PLANNING COMMISSION AGENDA

CITY OF DAYTON, MINNESOTA

ITEM:

Kwik Trip 1187

SITE PLAN (LAYOUT)	
CONVENIENCE STORE #11187 WITH SIDE DIESEL	
MAPLE COURT & HOLLY LANE N DAYTON, MINNESOTA	
#	DATE DESCRIPTION
1	10/25/21 Per City Comments
2	
3	
4	
5	
DRAWN BY	JTR
SCALE	GRAPHIC
PROJ. NO.	9354-00
DATE	2021-08-18
SHEET	1187 SP2

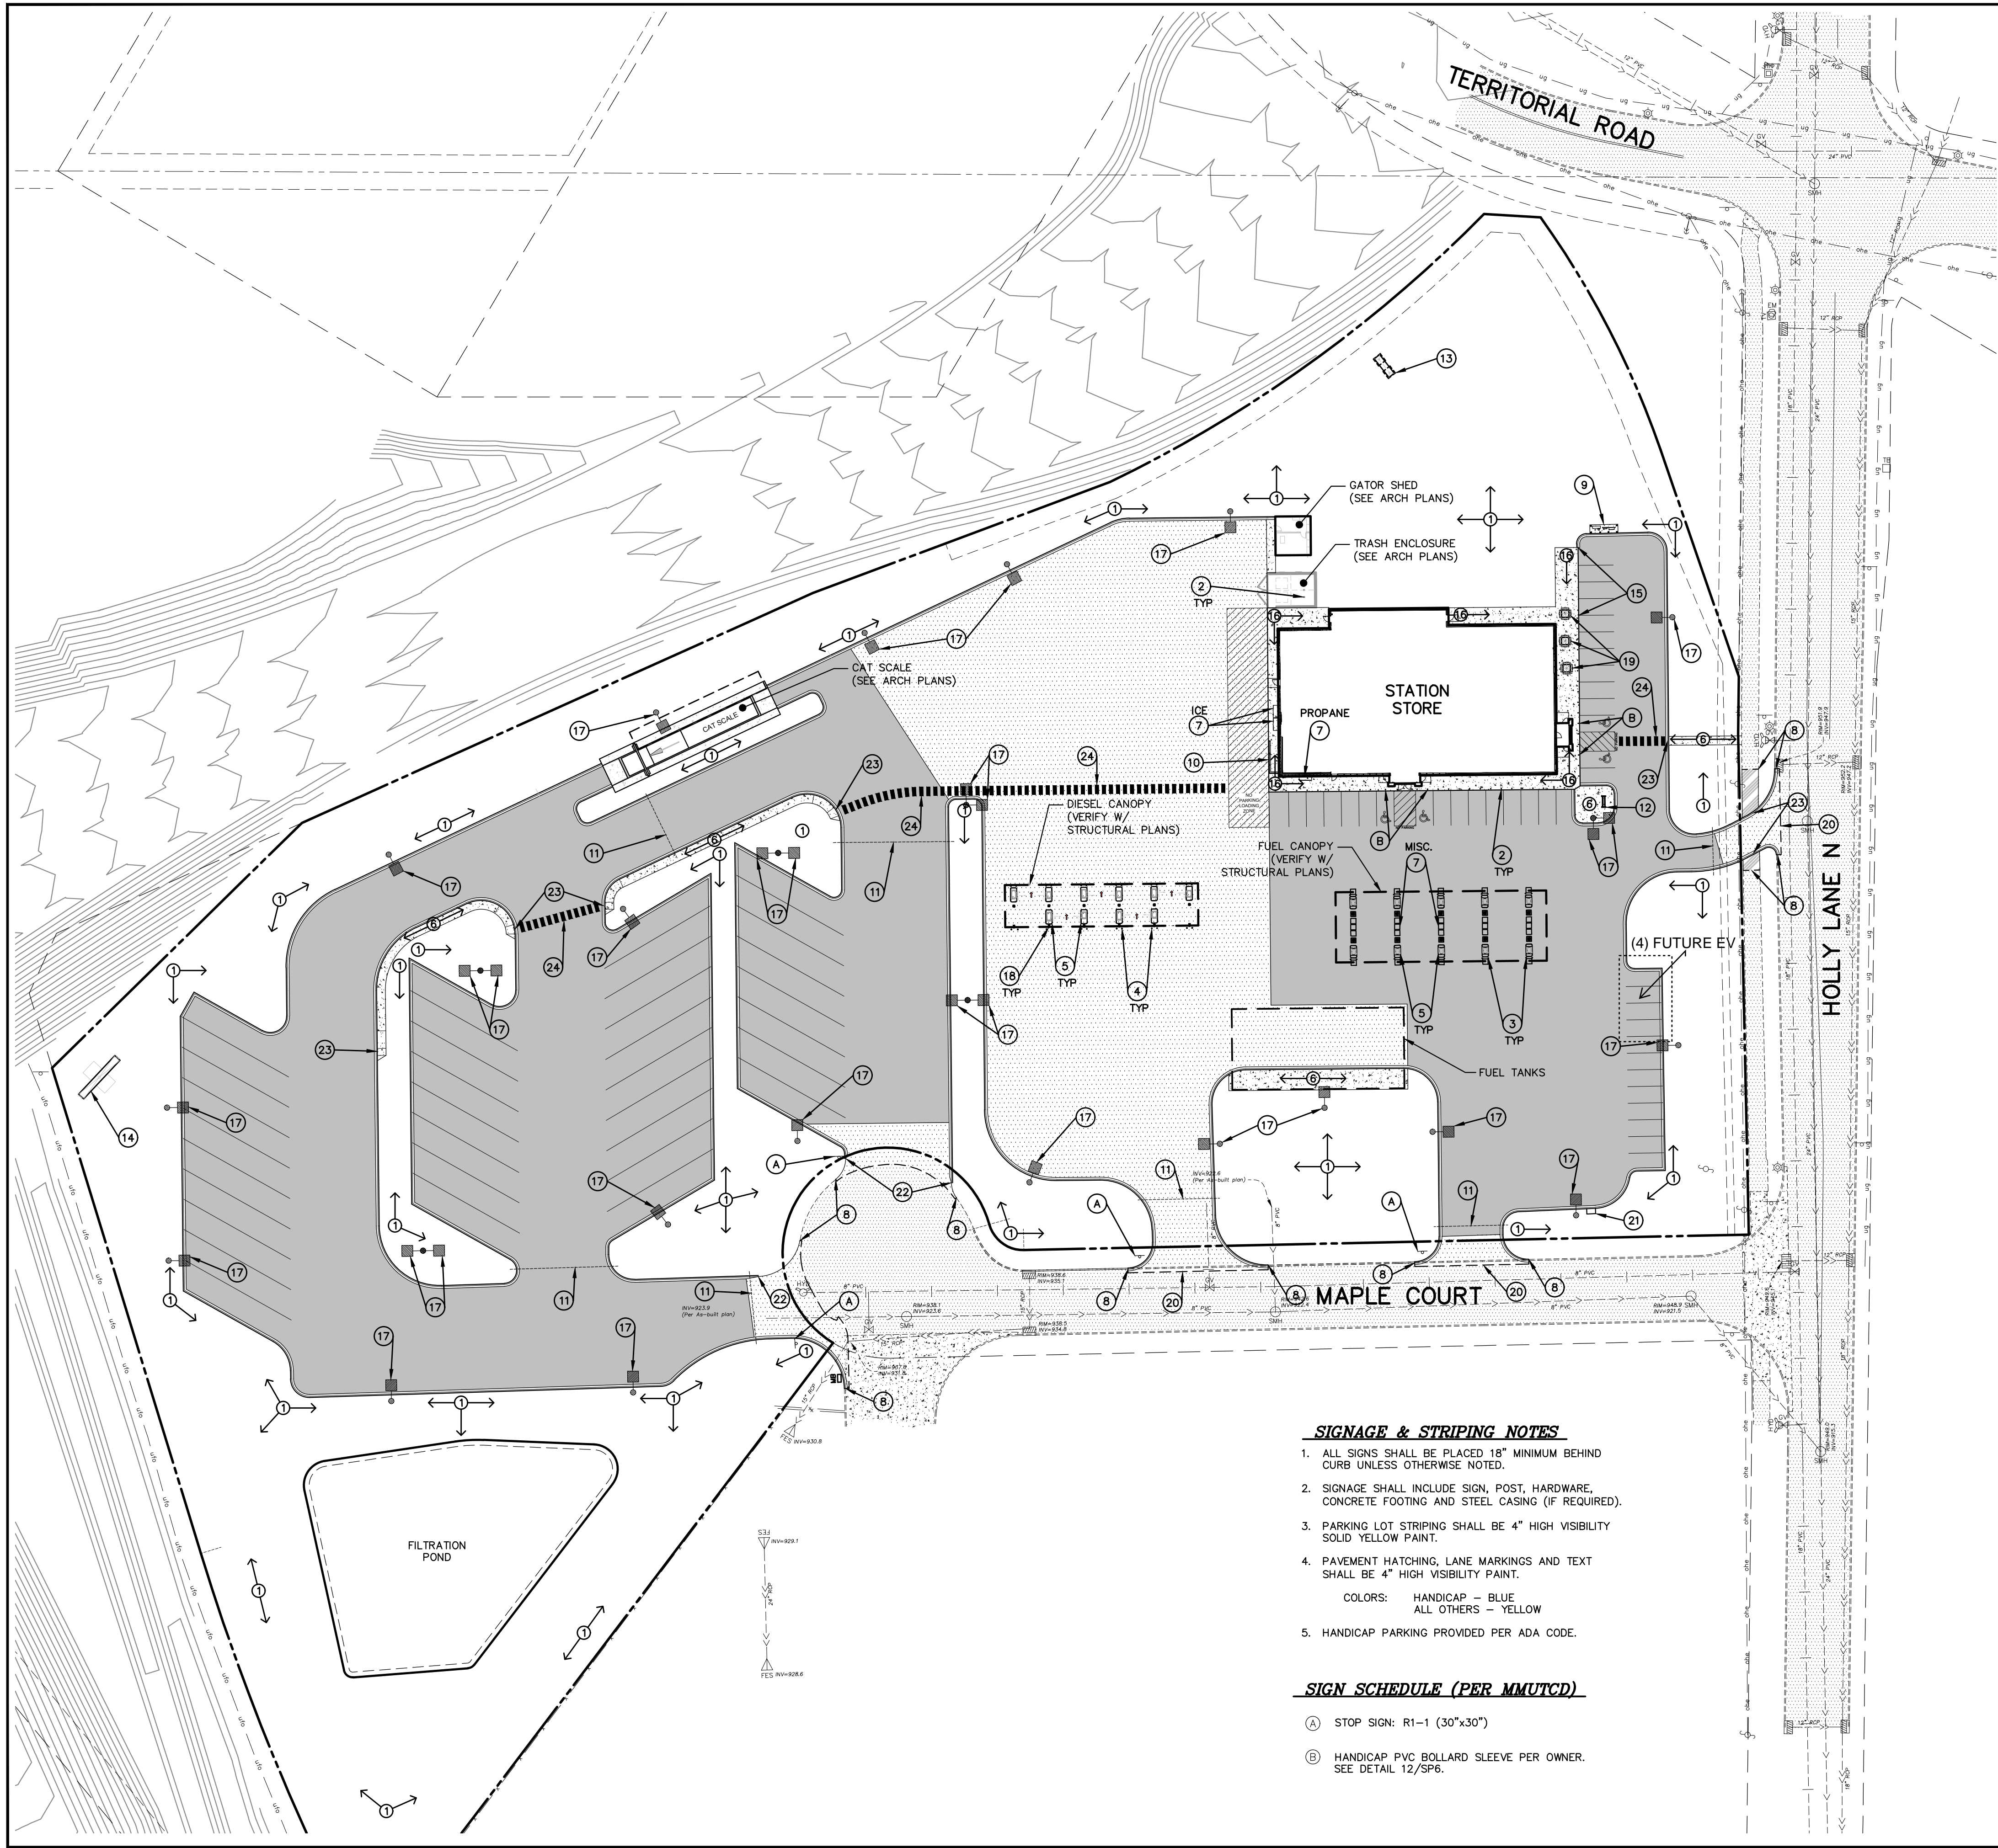
The parking lot/drive aisle in the SE corner is 16.5' set back from Maple Court whereas a minimum of 20' is required. There is space to comply.

Vehicle related services require two stalls + one stall per 250 sq ft of building used for retail. The building's floor plan was not submitted with the plan set, which is needed to confirm parking stalls.

Proposed parking stalls are 9.5' X 20' whereas 10' X 20' is required.⁶

Parking. Confirmation is needed regarding required number of parking stalls. Stalls need to be adjusted from 9.5' width to 10' width.

SITE PLAN
1" = 80'-0"

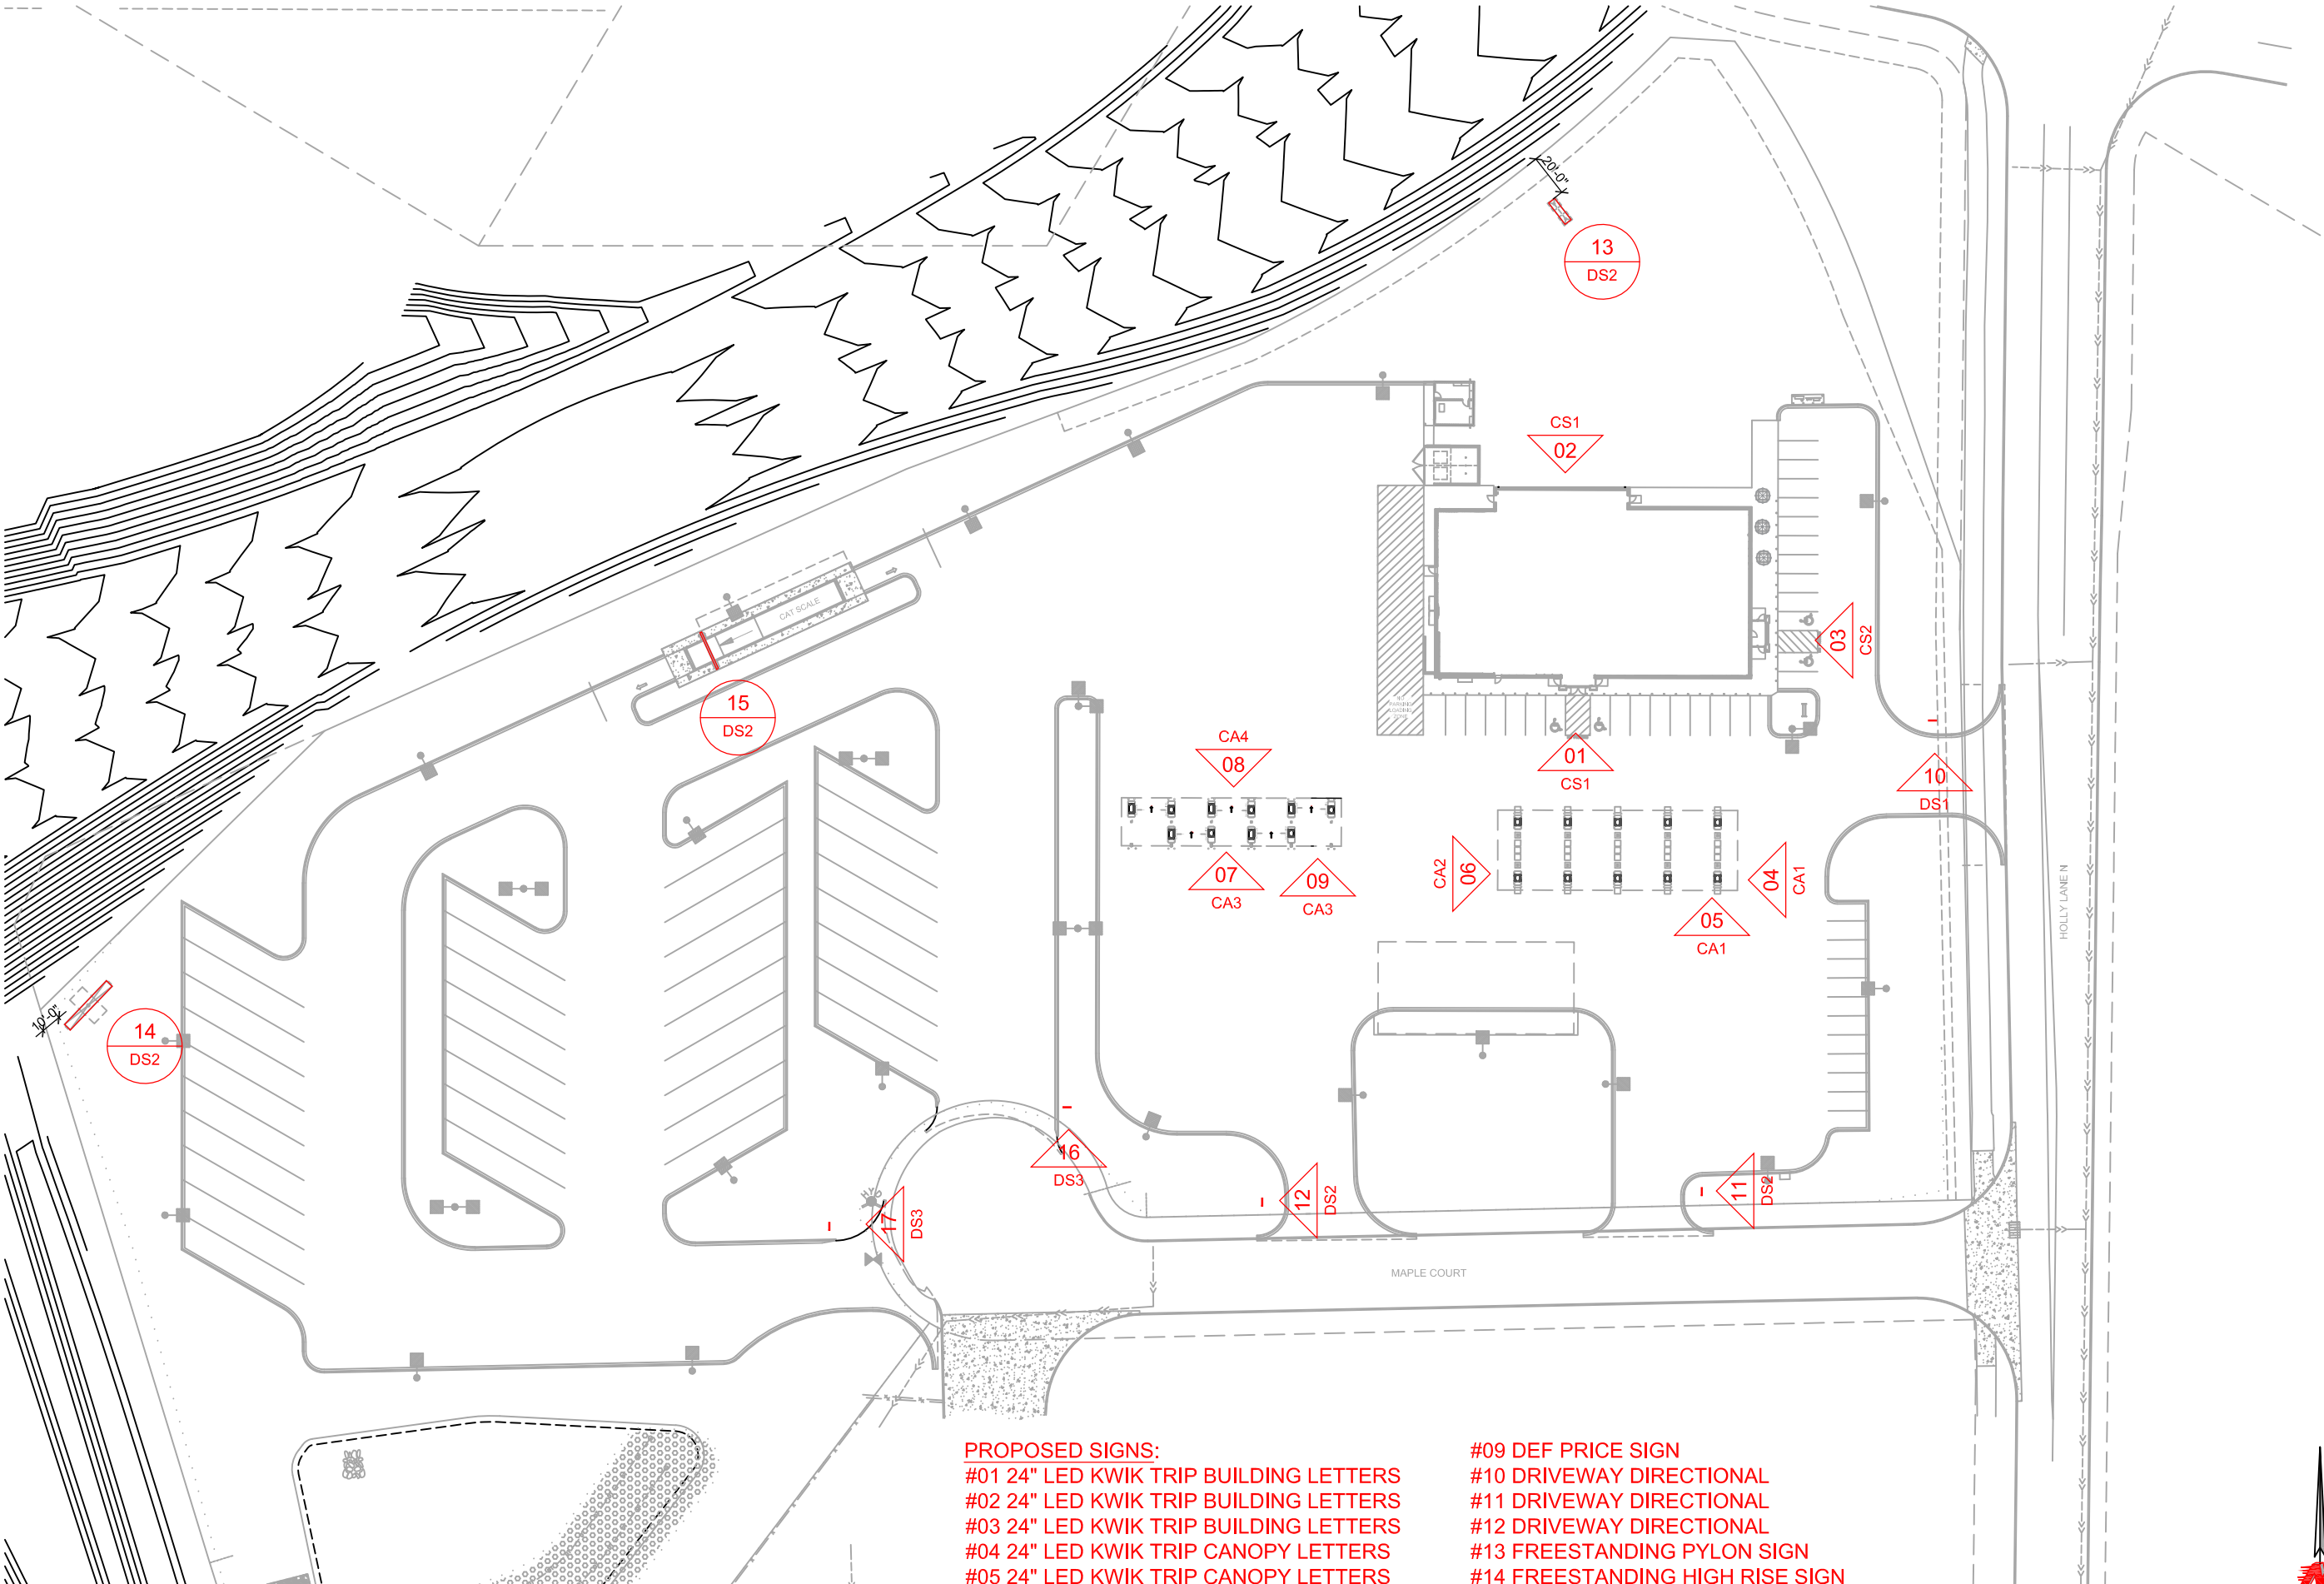
Landscaping ⁹		Required	Proposed
Over-story tree	1 per 3,000 sf open area	57	57
Ornamental tree	1 per 1,500 sf open area	114	114
Evergreen tree	1 per 3,000 sf open area	57	57
Shrub	1 per 100 sf open area	1,704	557

Staff suggests that the Applicant provide an alternative Landscape Plan for City Council review, with the required number of shrubs shown. The Council may opt to reduce the number required based on site conditions.

Landscaping. 1,200 additional shrubs are required. The Planning Commission should provide an opinion if this is necessary.

DOUBLE FACE PYLON

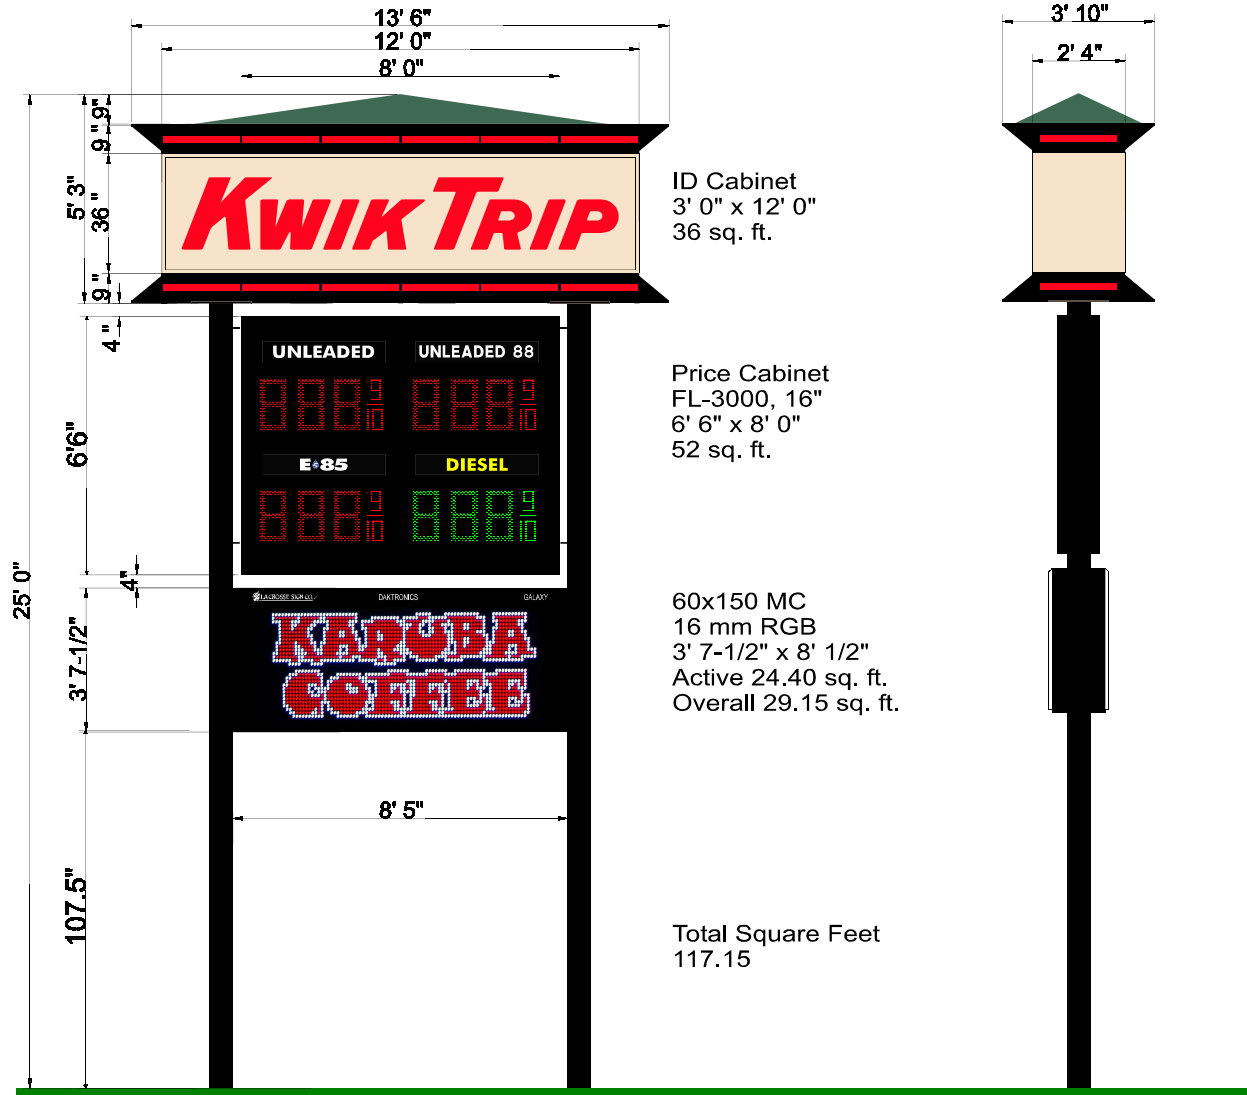
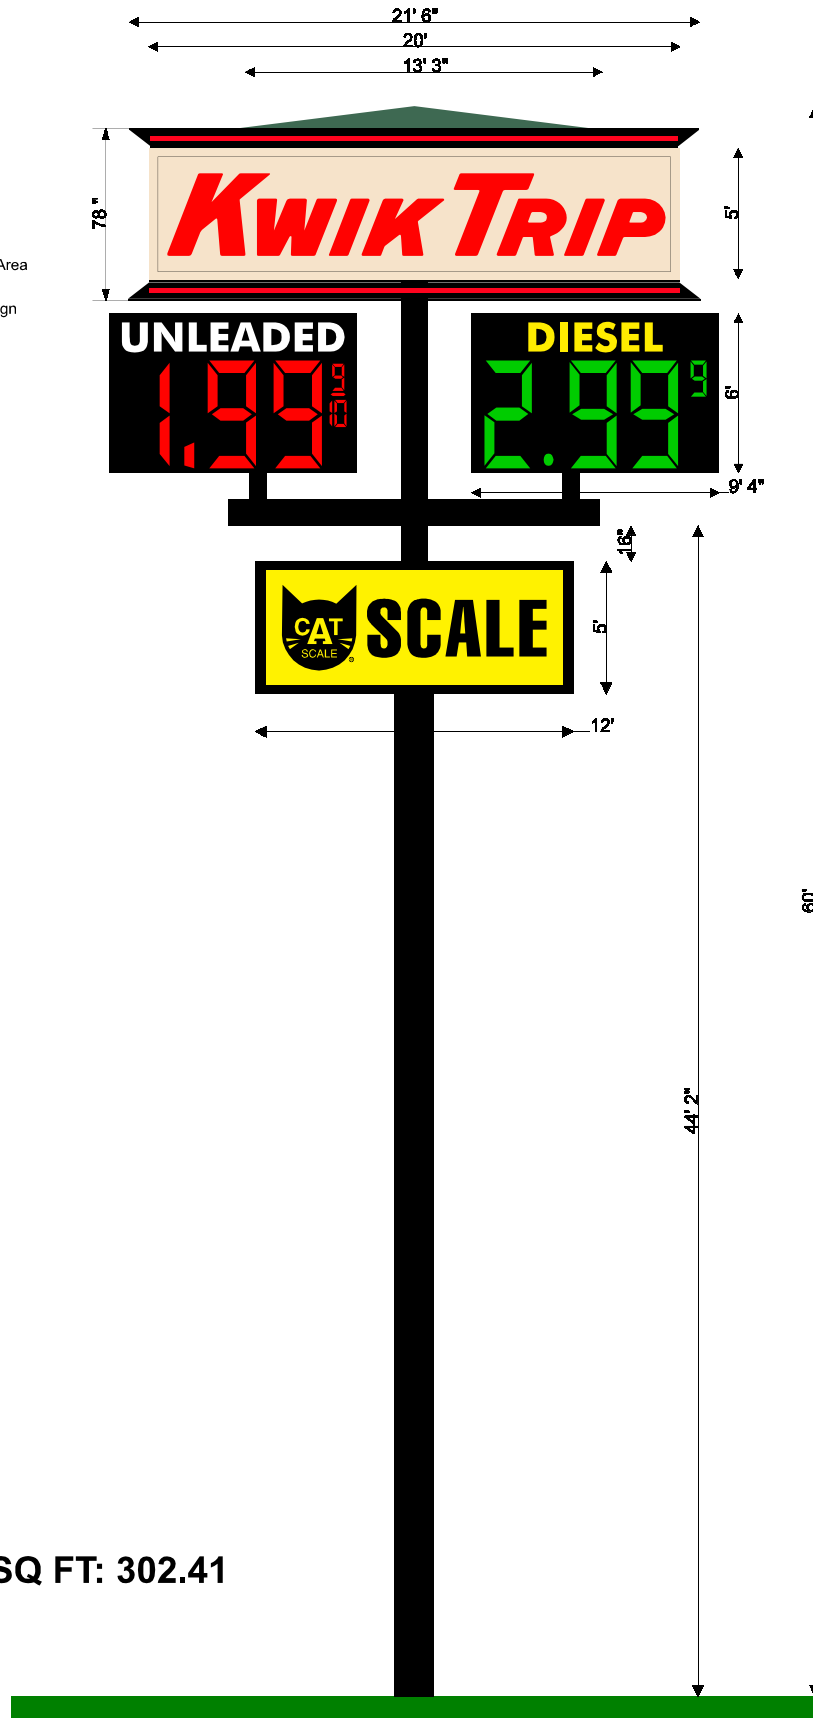
Signage. Applicable to this project, the City Code allows two free standing signs, 25' in height, 64 sf in area, pylon or monument masonry sign.^{11 12}

1. 60' pylon sign in NW corner, 302 sf in area.
2. 25' pylon sign in NE corner, 117 sf in area.
3. 16' pylon sign (CAT Scale), 100 sf in area.

The proposed NW pylon sign is about 22' below Dayton Parkway elevation. A Variance may be an option to permit a sign 25' above this grade (e.g. 50' tall sign). 60' is proposed by the Applicant. Size is still an issue.

1. 50' pylon sign in NW corner, 64 sq ft in area (requires Variance to height and to exceed 64 sq ft in area).
2. 25' masonry monument sign in NE corner, 64 sq ft in area, with dynamic display.
3. No CAT scale sign at scale location.
